CITY OF BERKLEY, MICHIGAN SPECIAL MEETING OF THE CITY PLANNING COMMISSION

To: Planning Commission
From: Kristen Kapelanski, Community Development Director
Subject: **PSP-15-22: 28557 Woodward – Seven Point Provisioning Center**
Site Plan Approval
Date: September 9, 2022

Re: Seven Points Provisioning Center
28557 Woodward Avenue
Engineering Site Plan – Review No. 2
City of Berkley, MI

Site Plan Review
For
City of Berkley, Michigan

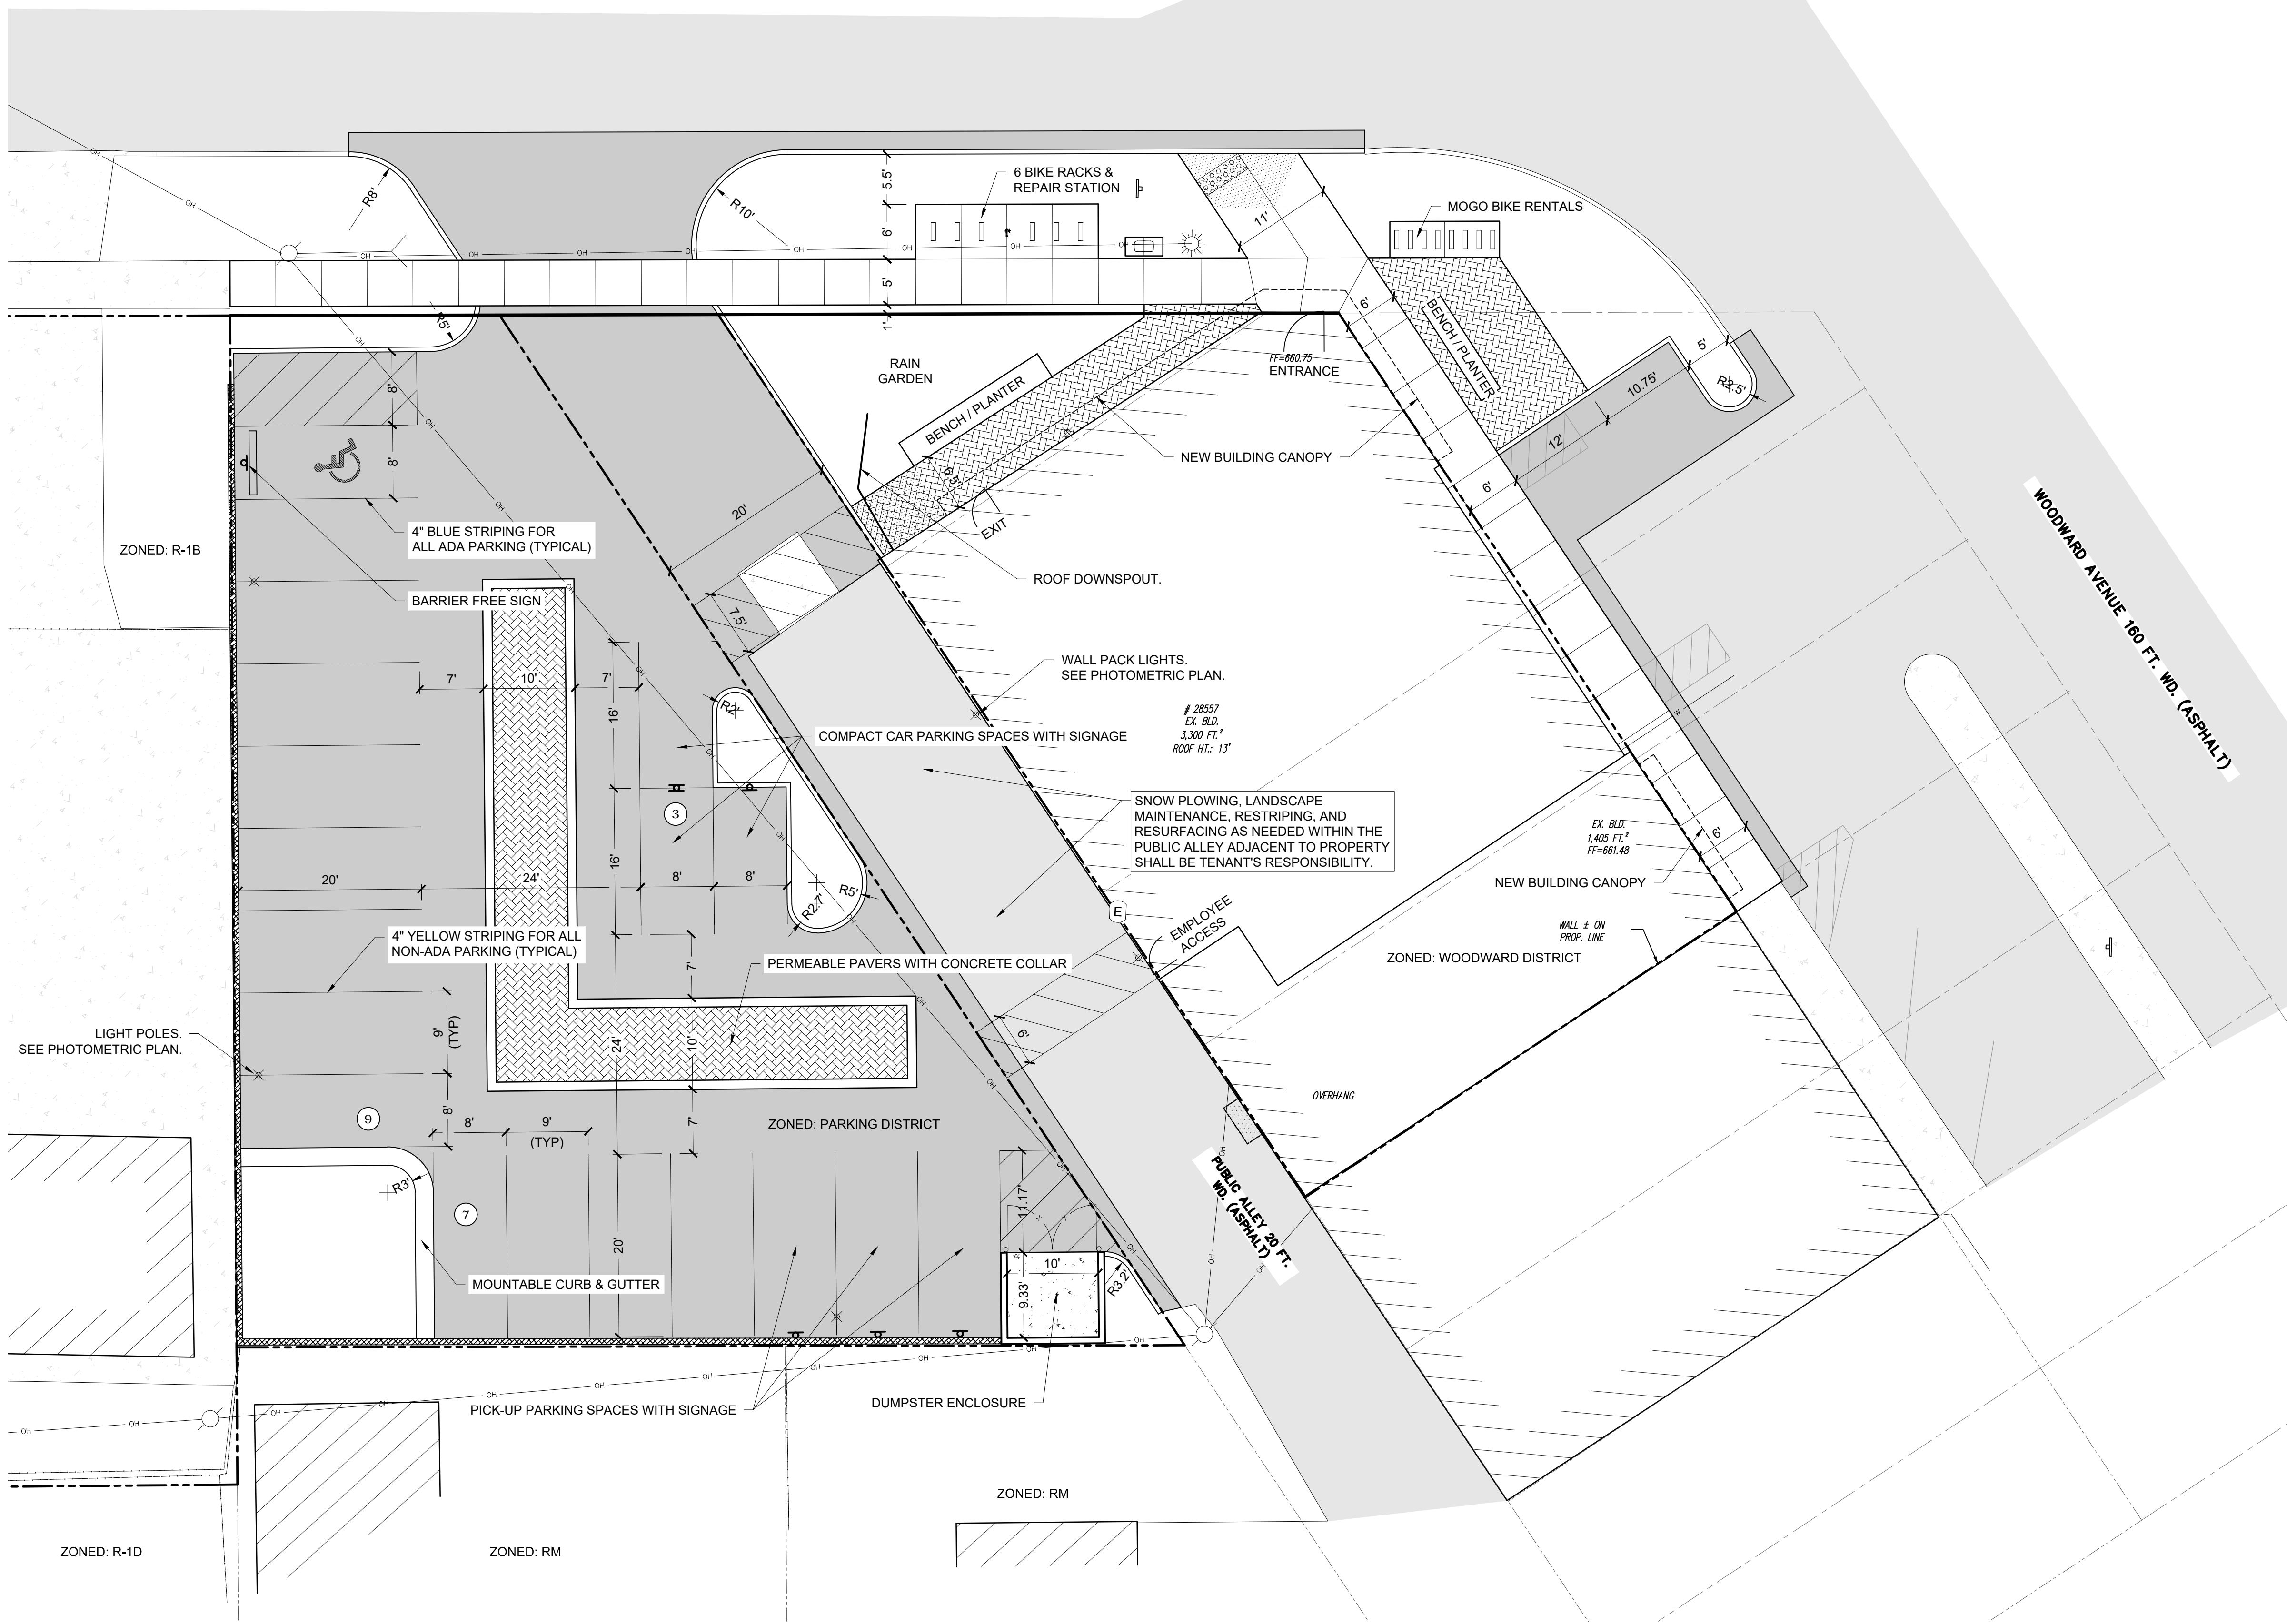
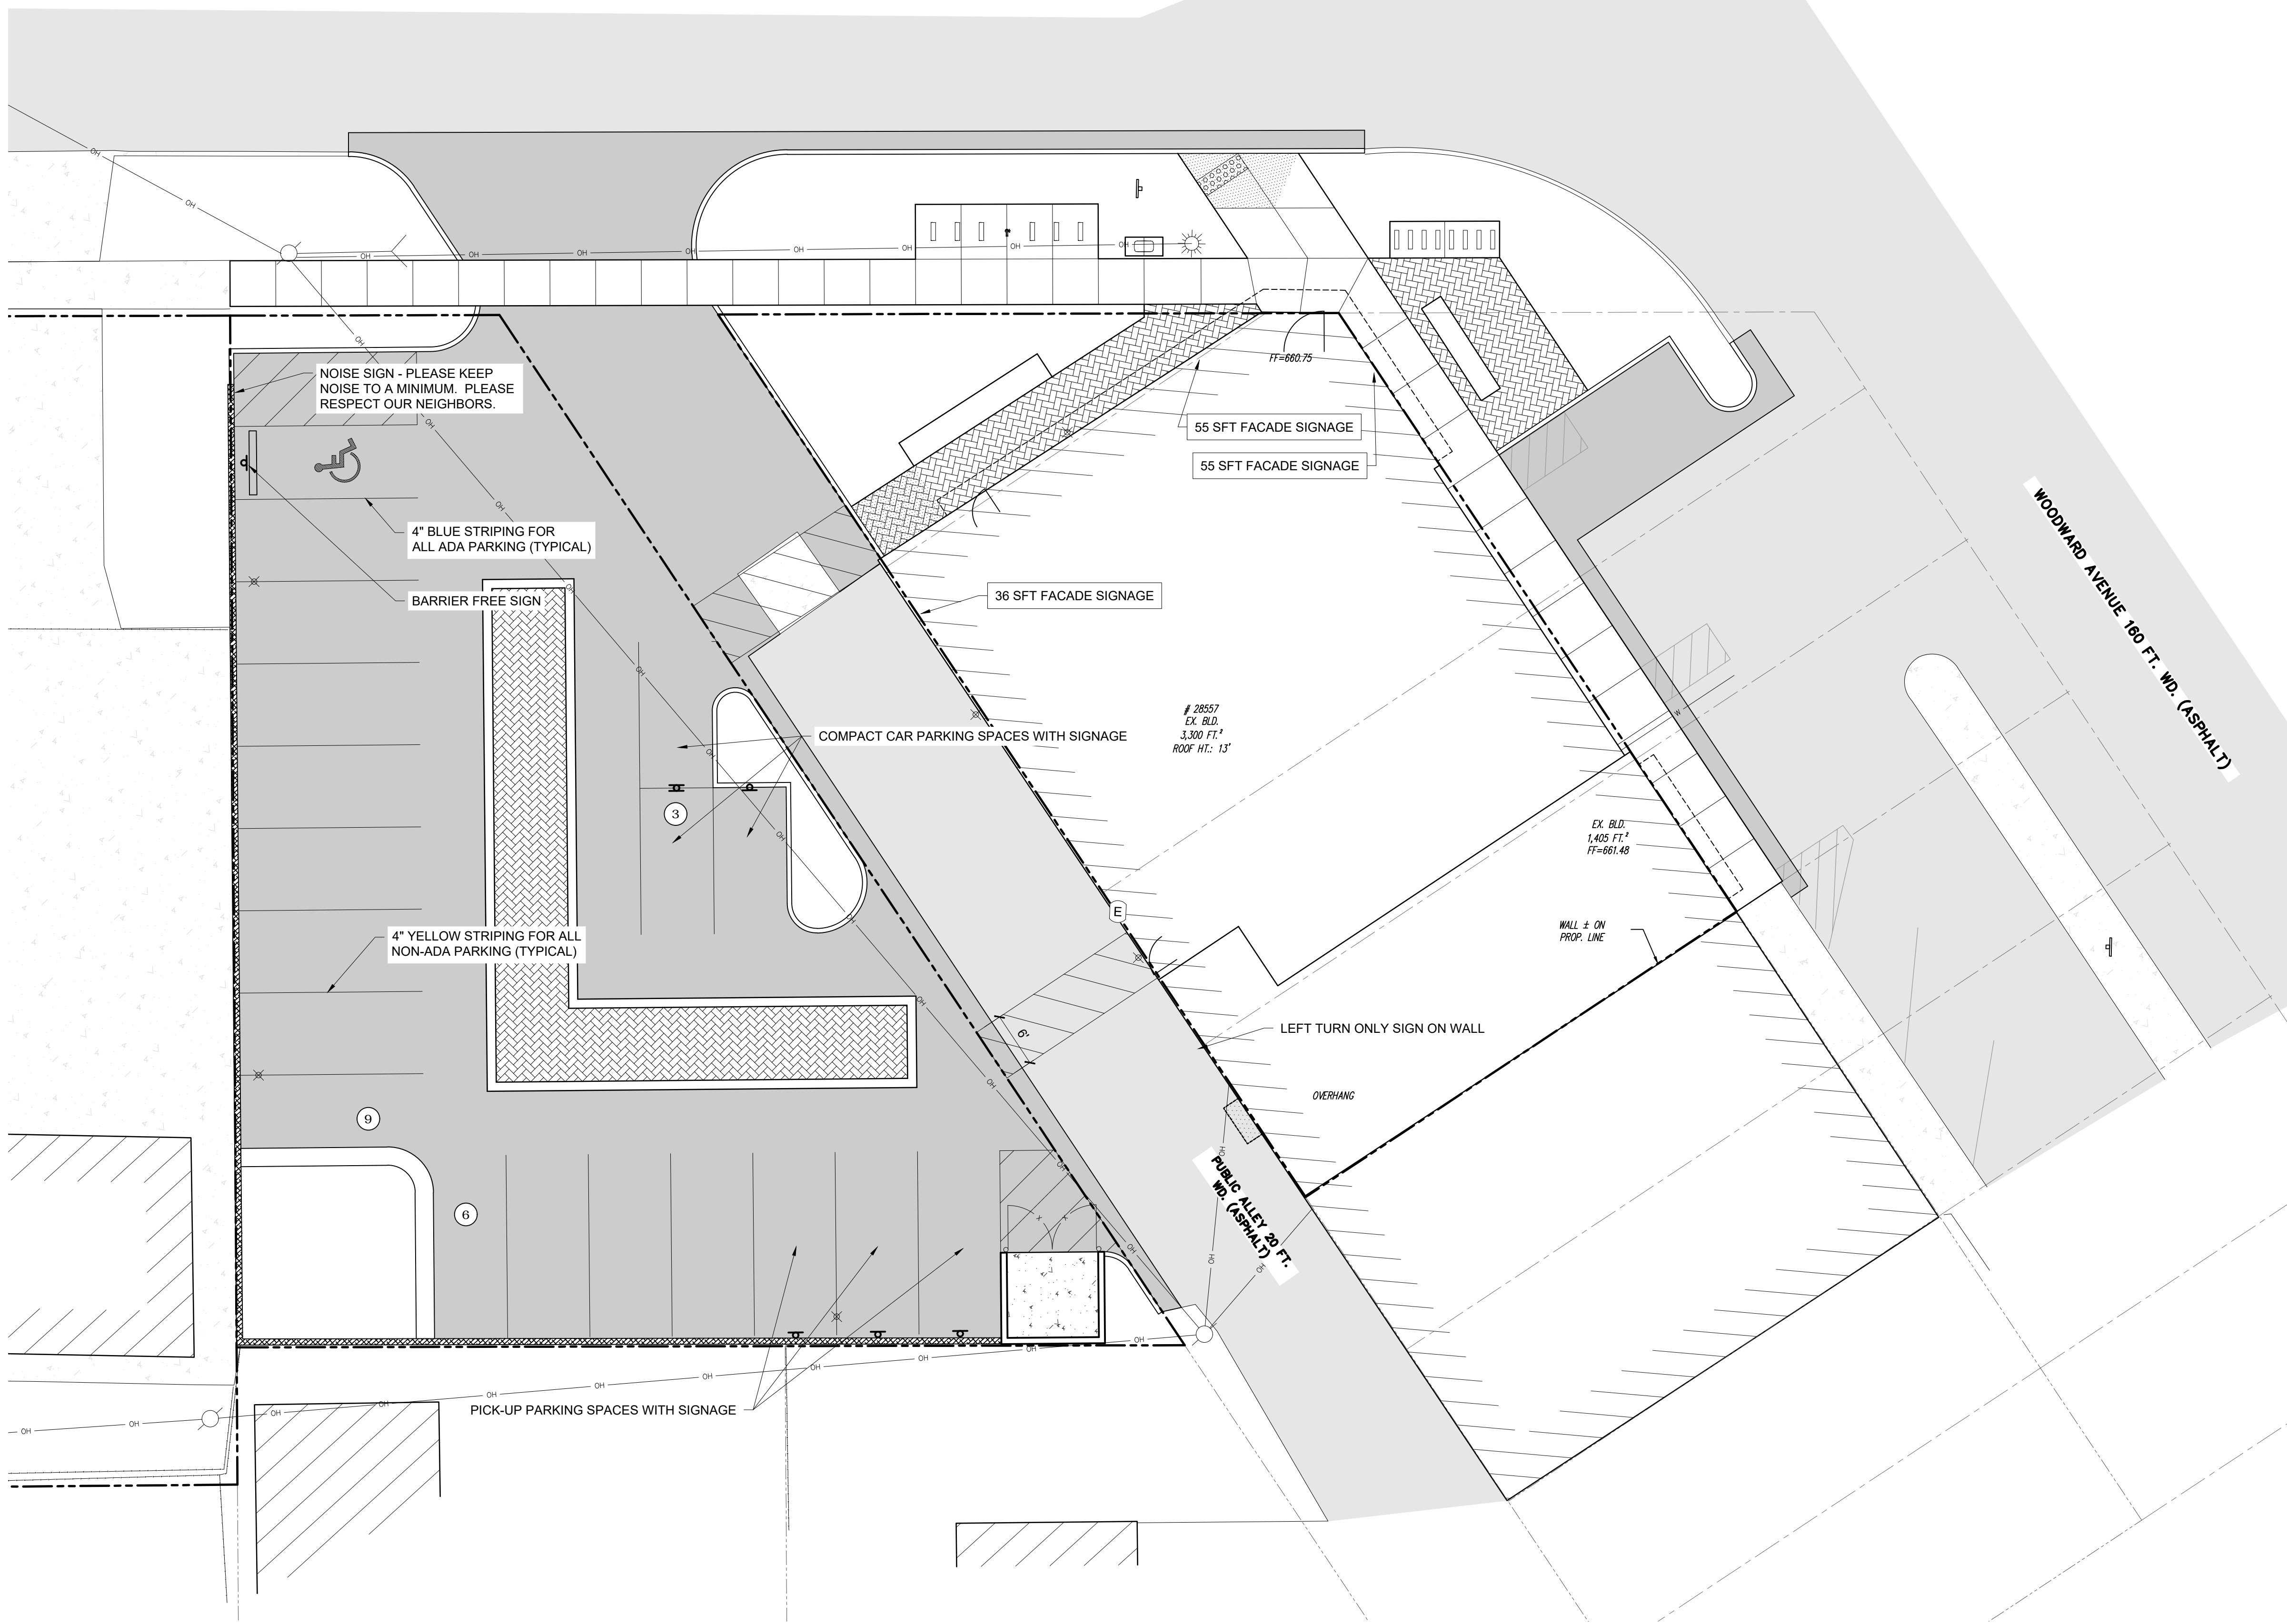
The applicant has provided a parking table on Sheet C102. This is a multiple tenant building. The parking required is a total of all uses combined in the building:

SEVEN POINT BERKLEY
28531-28557 WOODWARD AVE, BERKLEY, MI 48072
GRADING PLAN

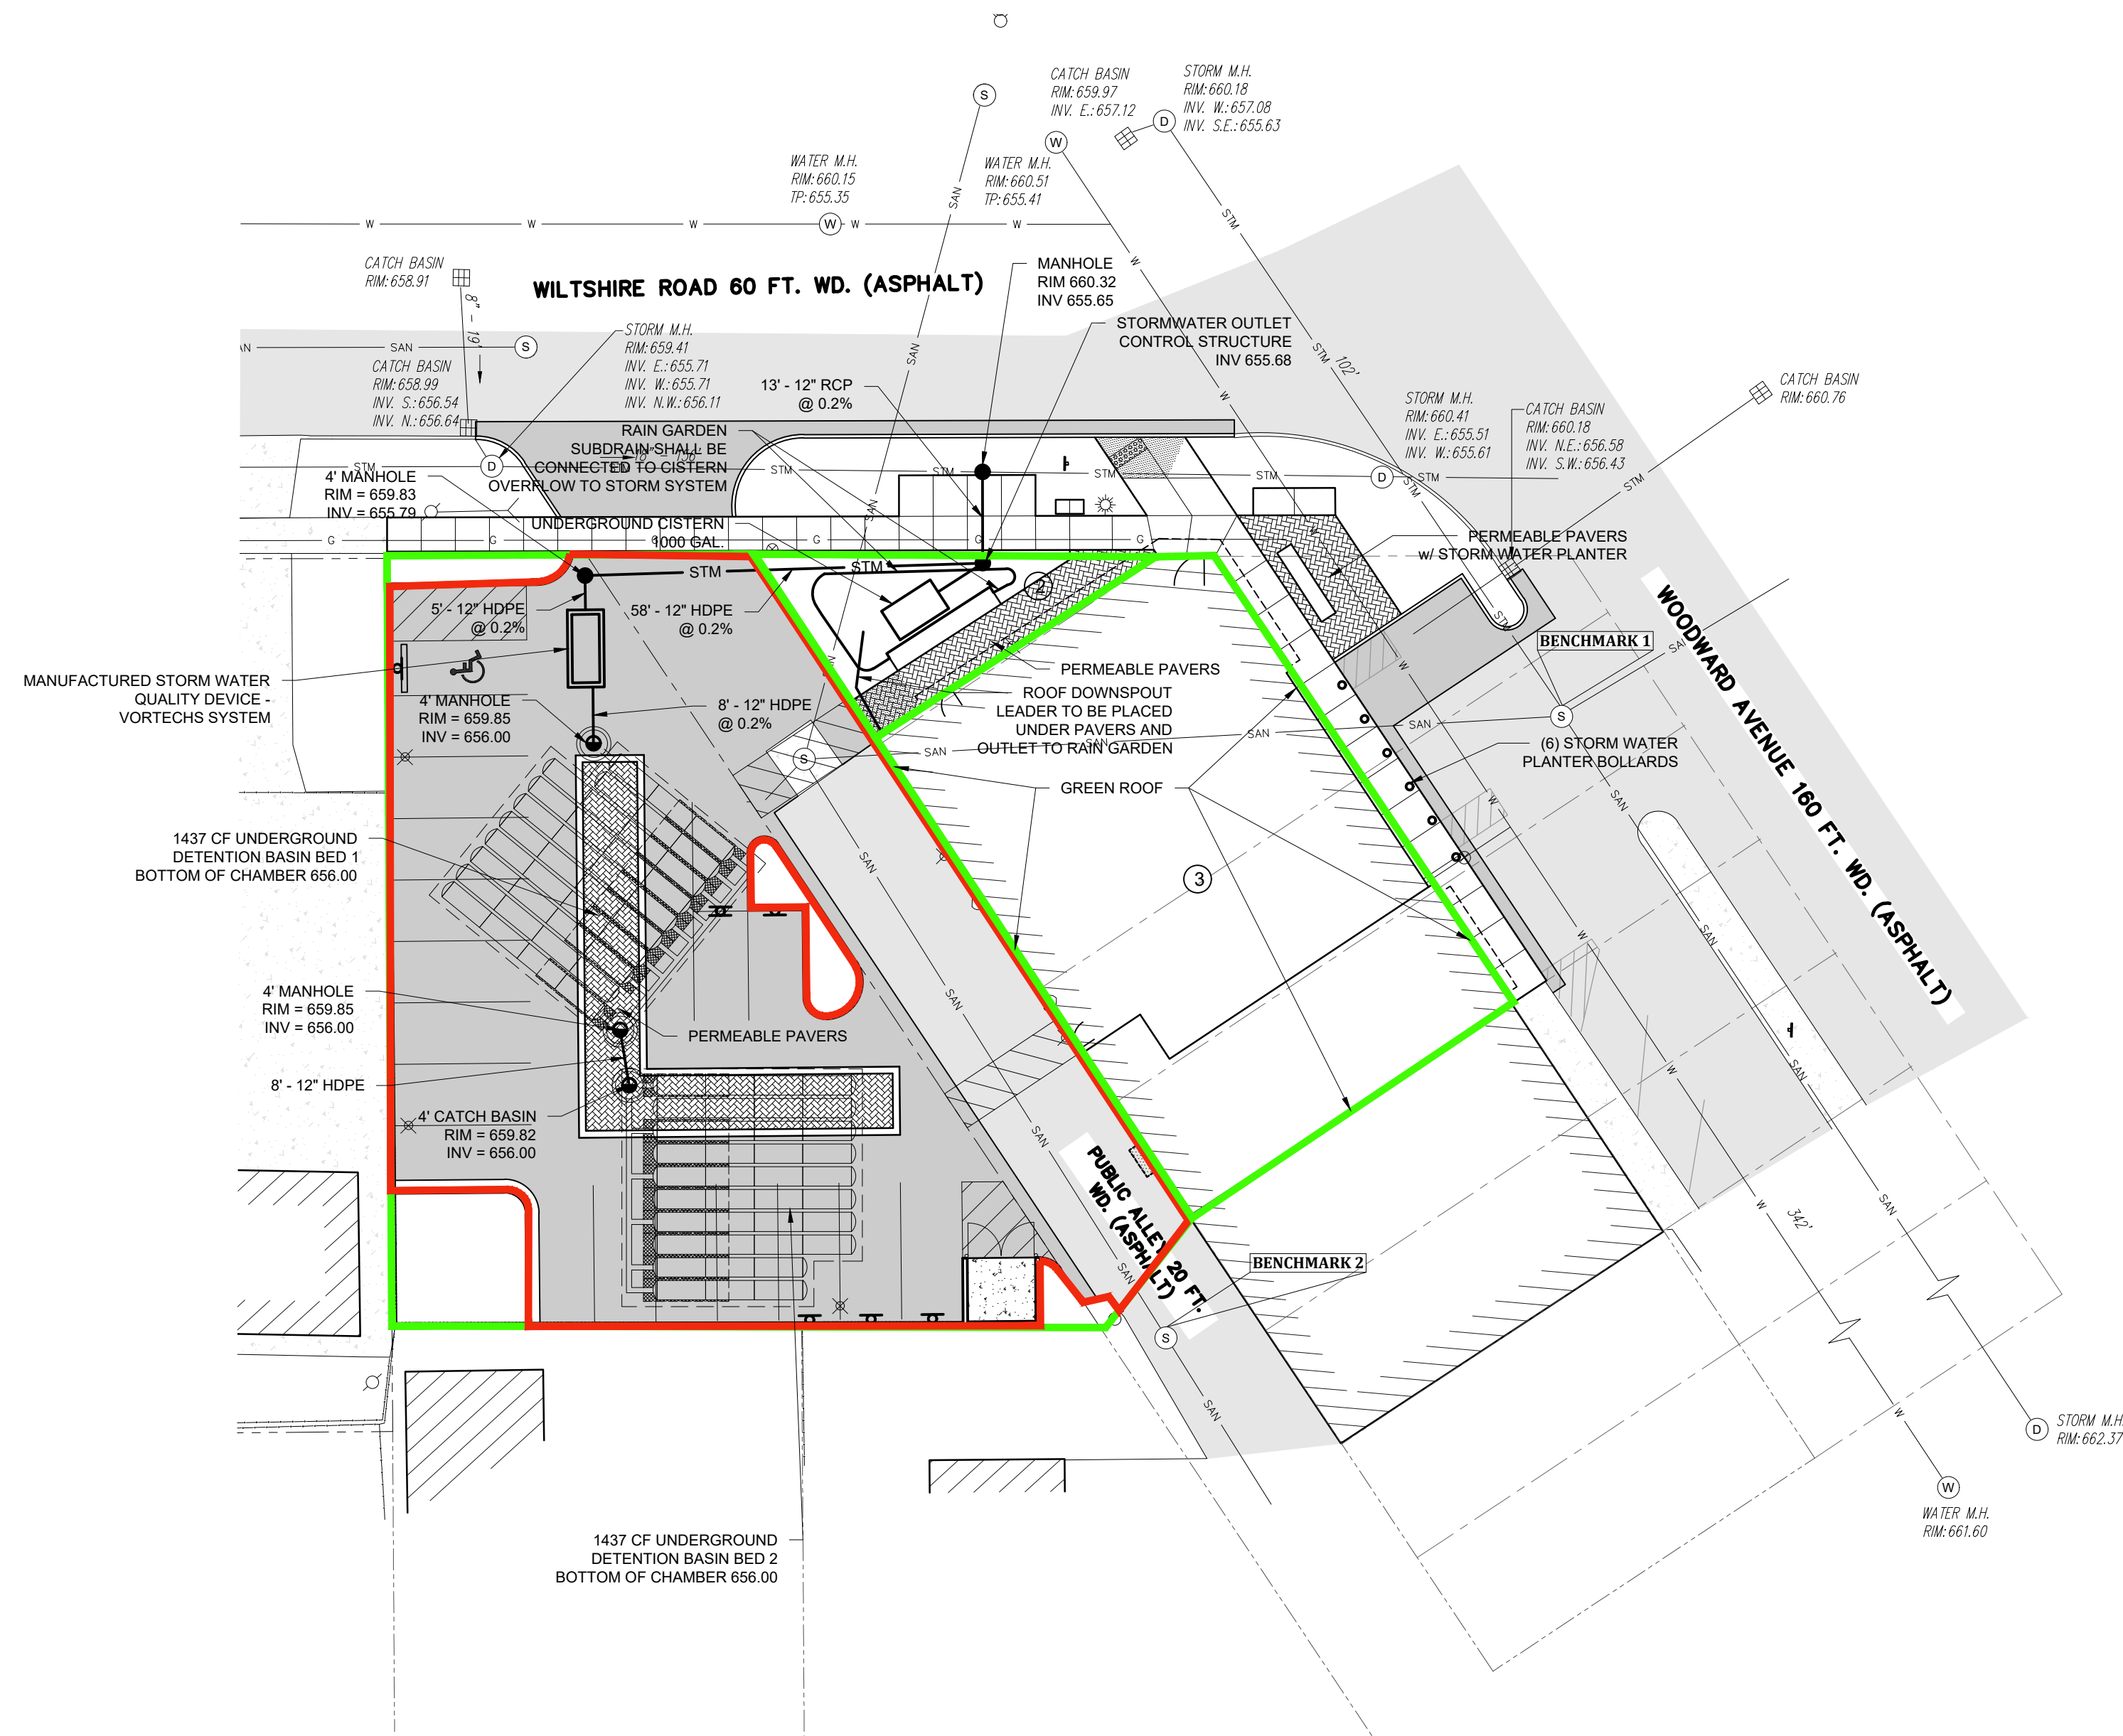
3. The StormTech Chamber System Detail shows a minimum cover of 48 inches from the invert of the chamber to the **bottom** of the proposed pavement. The grading plan shows only 48 inches of total cover from the invert to the **top** of proposed pavement, which does not meet this requirement. The cover must be revised to meet manufacturer specifications. **The plans have been revised to use smaller chambers and the grading plan shows that adequate cover is proposed above the storm system. This item has been satisfactorily addressed.**
